PRELIMINARY PLANS

Preliminary Plans Approved:  
JDB  
12/3/15

NO.	DATE	REVISION	BY
<b>Michael Baker</b> MICHAEL BAKER INTERNATIONAL 735 N. WATER STREET SUITE 1205 MILWAUKEE, WI 53202			
STATE OF WISCONSIN DEPARTMENT OF TRANSPORTATION			
ACCEPTED _____ CHIEF STRUCTURES DESIGN ENGINEER DATE			
STRUCTURE B-40-285-27F-2			
IH 94 EB/IH 43 SB OVER MENOMONEE CANAL			
COUNTY	MILWAUKEE	TOWN/CITY/VILLAGE	MILWAUKEE
DESIGN SPEC. REHABILITATION N/A			
DESIGNED BY	JMK	DESIGN CK'D.	JRB
DRAWN BY	MMW	PLANS CK'D.	JRS
CONCRETE OVERLAY			SHEET 1 OF 5

TYPICAL SECTION

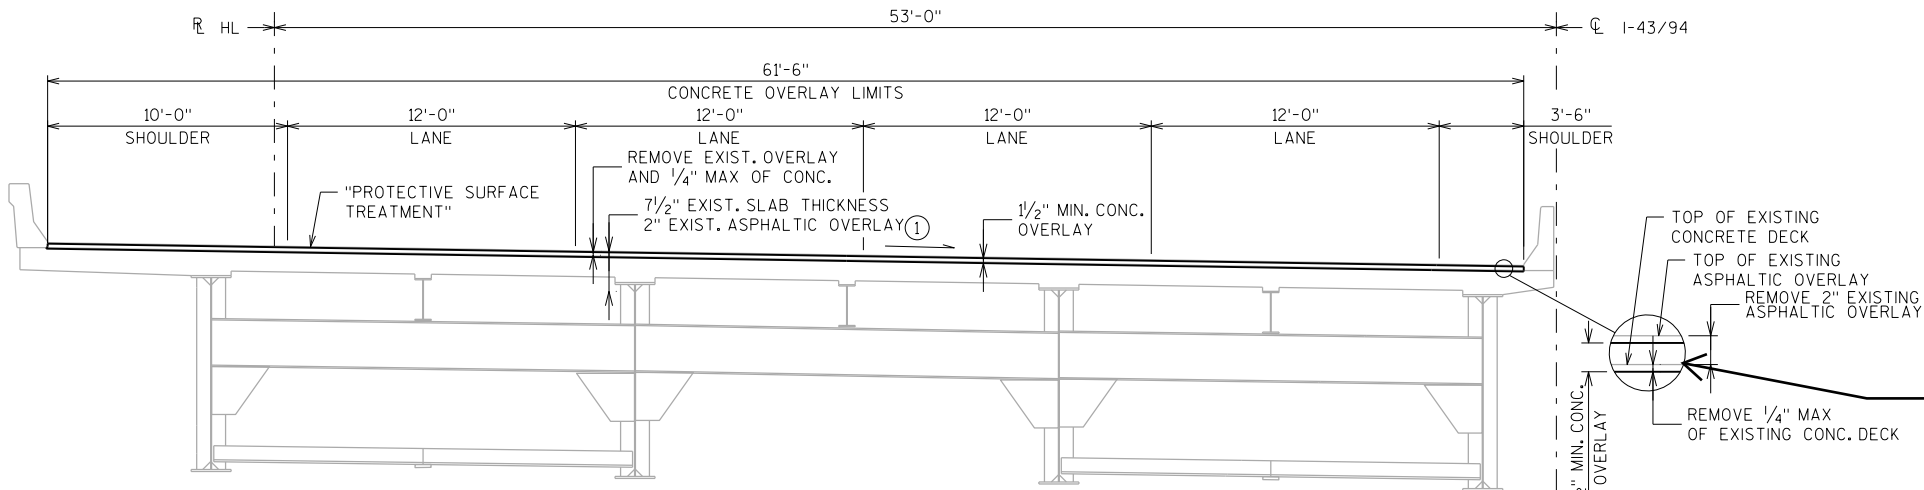
Sheet membrane waterproofing layer between asphaltic overlay and concrete deck

Include girder size / spacing on typical section drawings
